Title		
T3-8I-13R		
Size B	Document Number	Rev
	POWER	08
Date: Saturday, November 23, 2013 Sheet 3 of 6

InOut Relay Rev4

T3-8IN-13RELAY_REV08

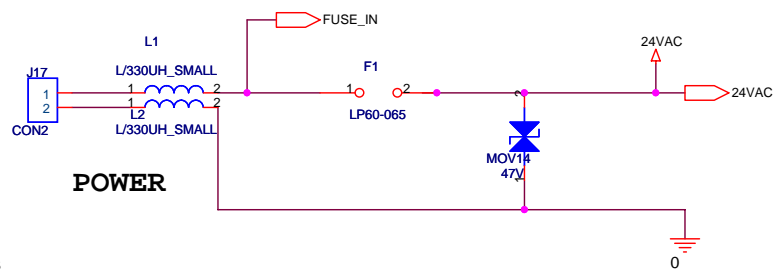
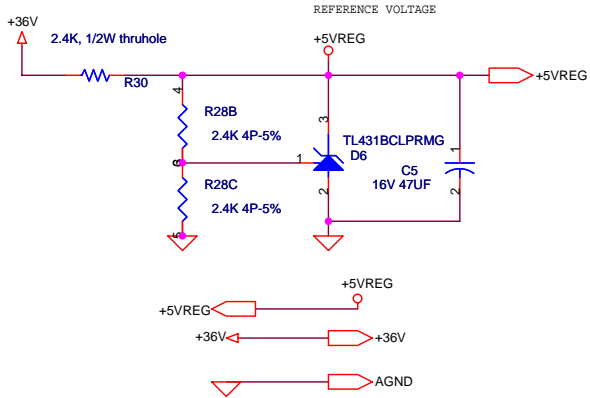
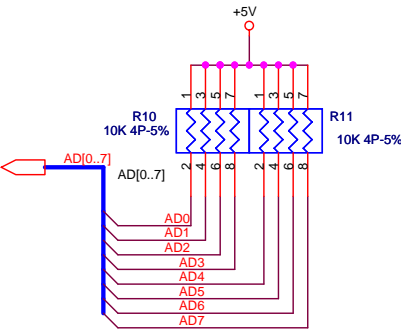
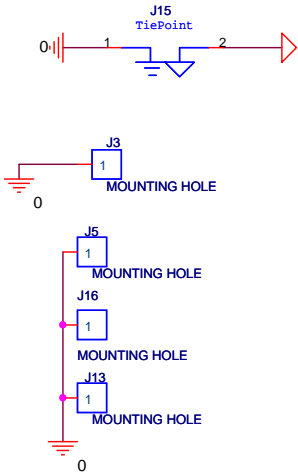
TBD: on analog board, all the above chanegs

TBD: isolated network gnd

TBD: change riser card header from 0.1inch to 0.2 inch

TBD: on upper board, no vias allowed under switches, add 4 holes to switch footprint

TBD: try to pass 110VAC on any pin

Title		
T3-8I-13R		
Size	Document Number	Rev
A	SERIAL PORT	08
Date:	Thursday, December 27, 2012	Sheet 5 of 6

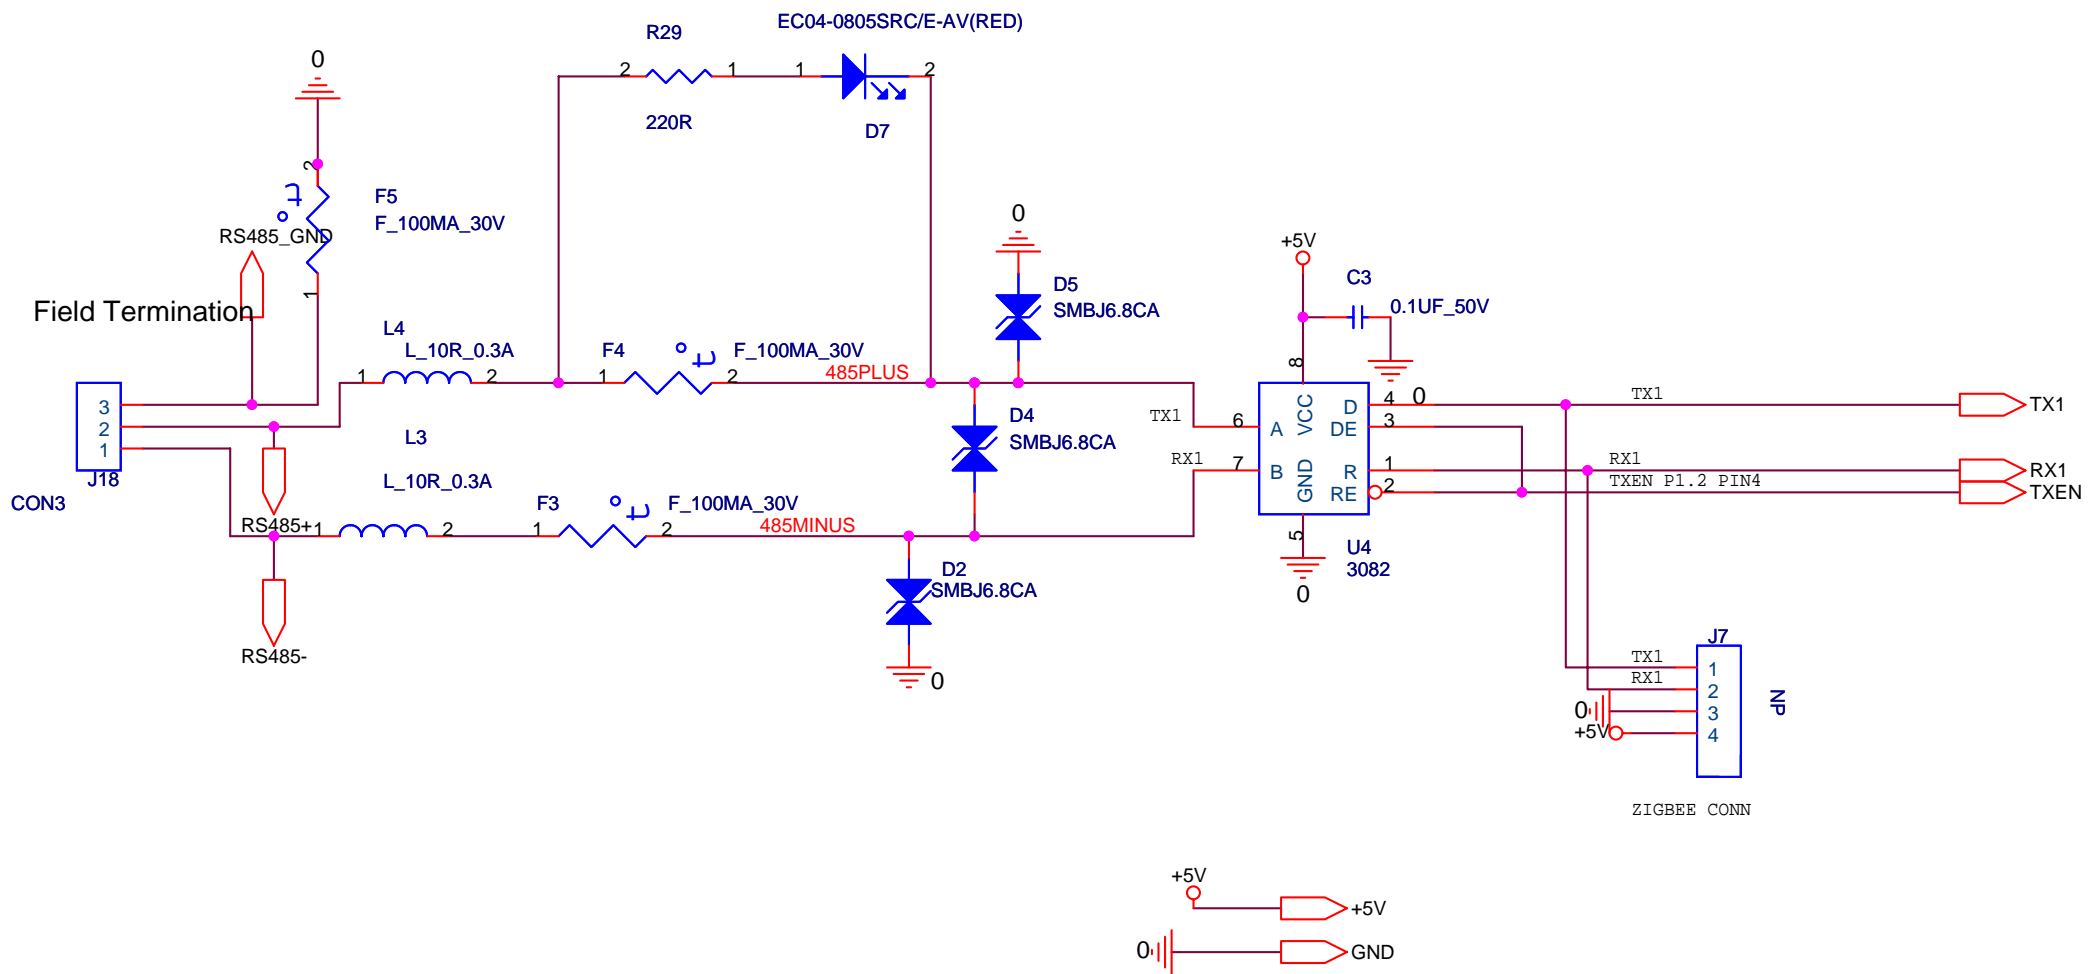
DONE: CHECK ALL SCREW TERMINALS WITH 24VAC ON REV7 BEFORE MAKING REV8

DONE: change this to fuse symbol, not R, update born, SAME PART# AS TSTAT6

DONE: need to add zigbee header

DONE: J6 PIN24 ADD +36V FOR +5VREG INPUT .

DONE: Add RS485 LED .

TBD: change the input resistors from 1k to 10k
